## COASTAL MANAGEMENT PLAN McWILLIAM PARK TUROSS HEAD

PREPARED BY
DUAL DESIGN
MORUYA
FOR
TUROSS LAKES PRESERVATION GROUP INC.
1998
ADOPTED WITH AMENDMENTS BY EUROBODALLA SHIRE COUNCIL
23RD MARCH 1999

W10 Coastal Management Plan - McWilliam Park, Tuross Head

- 1. To advise the Committee on the response received to the public exhibition of the Draft Coastal Management Plan for McWilliam Park, Tuross Head.
- 2. To recommend amendments to the draft Plan for final adoption.

APPENDIX A 1/2

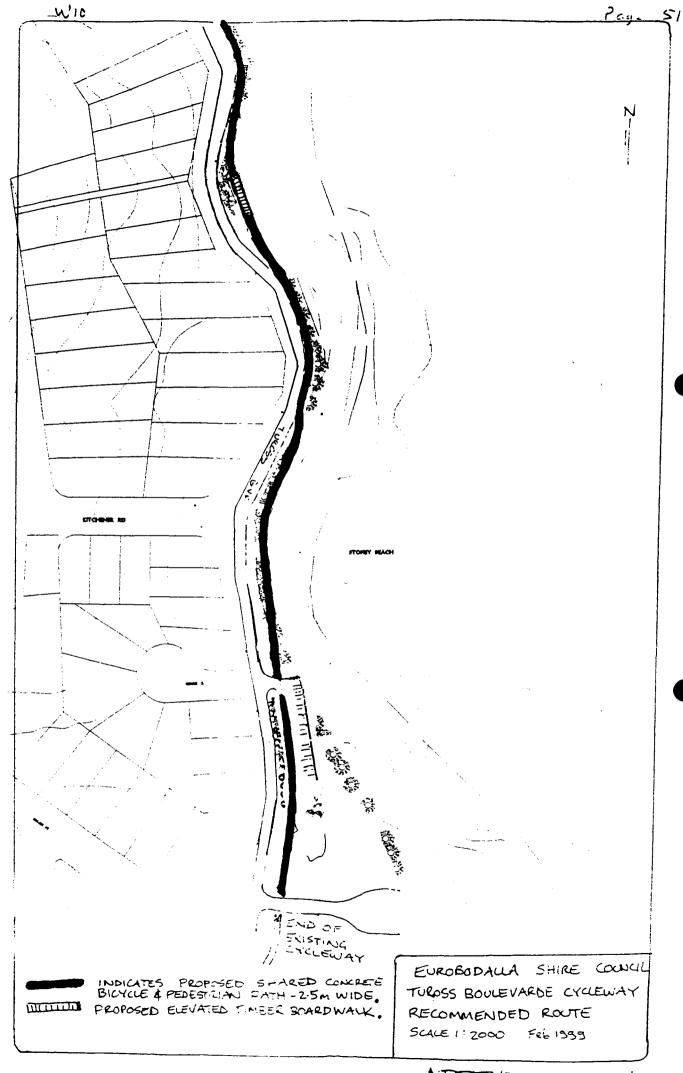
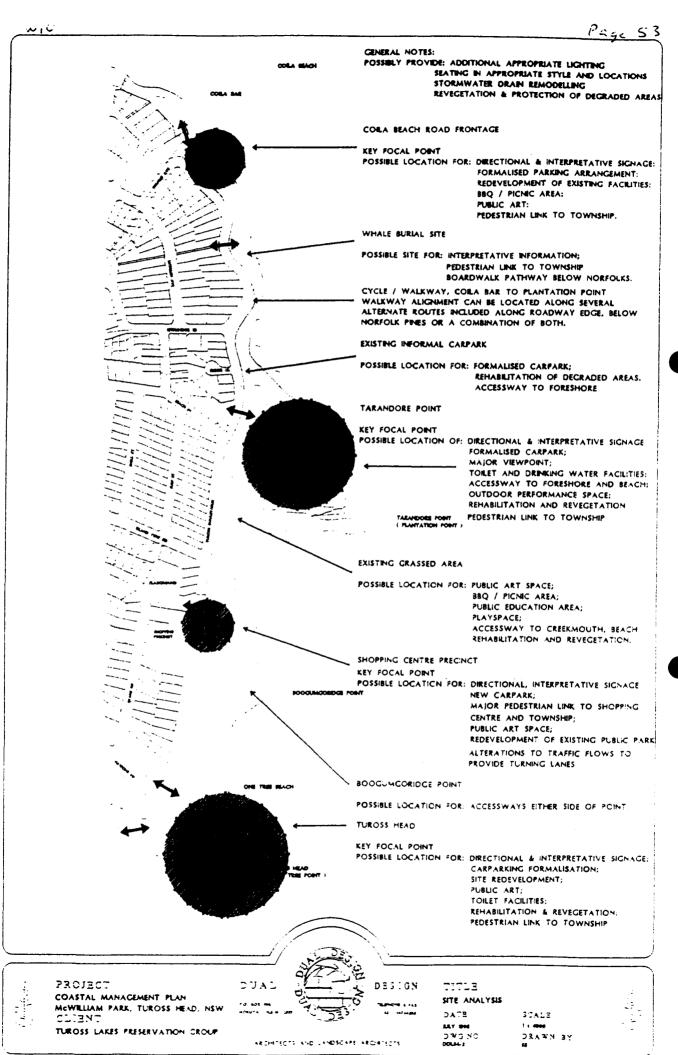
- 15.1 Use gravel surface instead of concrete to help reduce damage to Norfolk Pine roots.
- 15.2 Delete boardwalks and use gravel, cost saving.
- 15.3 Reduce width below RTA standards in tight sections.
- 15.4 Prefer timber boardwalk construction for cycleway rather than concrete with "cut and fill" engineered for stage 2. More aesthetic and environmentally sustainable.
- 15.5 Reduce size of boardwalk north of Stoney Beach carpark - should be concrete closer to roadway.
- Roadside cycleway should have pedestrian safety barrier. 15.6

- 15.9 Timber boardwalk is an eyesore. Give rise to litter along foreshore.
- 15.10 Cycleway should be built in conjunction with kerb and gutter to Tuross Boulevarde. Kerb will protect vehicle damage to tree roots. Provide pedestrian barriers at blind corners.

- 15.18 Volunteers preferred route is along roadway and in concrete. Safety concerns with traffic may be overcome using pine fencing.
- 15.19 Remove Pine Tree opposite No 45 so that cycleway can be better placed. Replant tree or build lookout.

It is the view of staff that plans should be developed in conjunction with kerb and gutter plans for the roadway so that the two projects are designed and constructed at the same time. (A draft Road Construction Program is currently before Council which nominates the roadworks be undertaken in 1999/2000).

It is recommended that the Plan be amended to show this preferred route subject to further engineering design. Appendix A indicates a concept layout of the preferred route.

(i) The Plans indicate the cycleway route as shown on Appendix A, that is in concept adjacent the roadway near future kerb and guttering alignment. The exact location of the pathway and roadway kerb and gutter will be determined subject to further engineering design investigation. A small timber bridge may be incorporated to cross the gully opposite the existing pedestrian walkway. The cycleway will mainly be constructed of concrete.

Consideration shall be given to the protection of existing trees during design and construction.

MASTERPLAN SHEET - 1
DATE SCALE

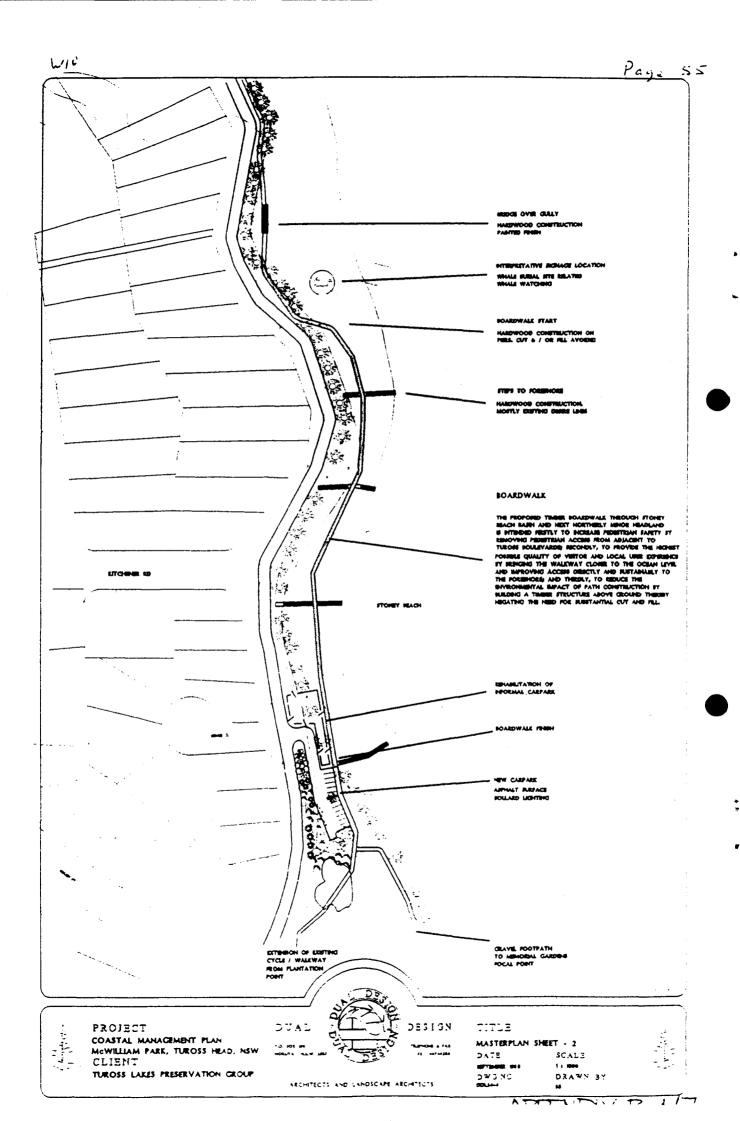
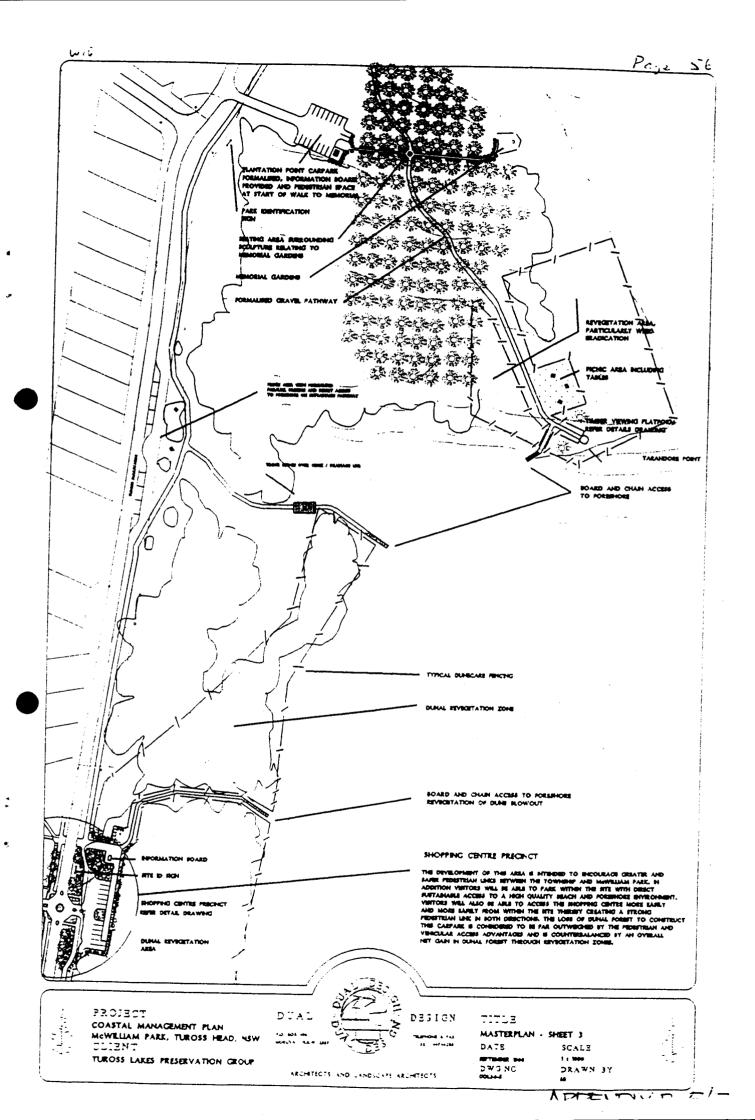
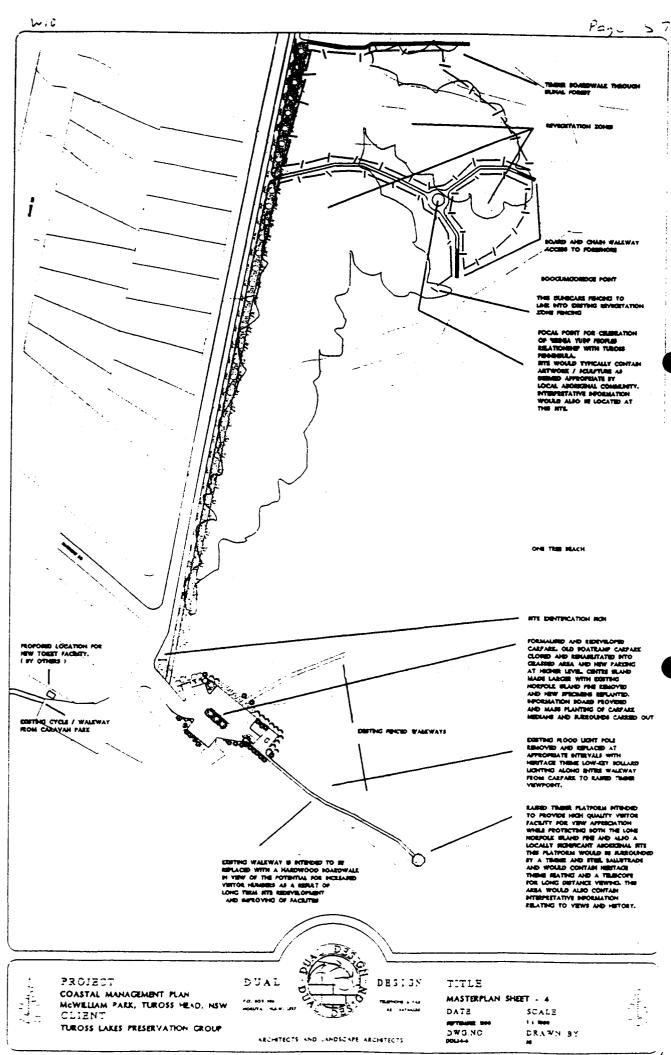
- 7.1 Delete carpark opposite shops and provide alternative verge parking.
- 7.2 Retain native vegetation and delete carpark. Protect region.
- 7.3 Showers should not be installed, discourage use of beach as it is dangerous.

- 7.1 It is recommended that the Plan indicate the carpark as a possible future development subject to demand and not a definite proposal. Alternative layouts such as verge parking will be considered.
- 7.2 Note to be added to Plan to indicate need for careful consideration of vegetation.
- 7.3 Showers are only a suggestion and would only be installed if there was a high demand.

- (e) The carpark opposite the shops should be noted as a possible future development subject to demand and not a definite proposal, with alternative layouts such as verge parking to be considered. In addition careful consideration should be given to protection of the existing native vegetation in this area. The roundabout to be deleted from the Plan with a note that traffic treatments are subject to Traffic Committee consideration.
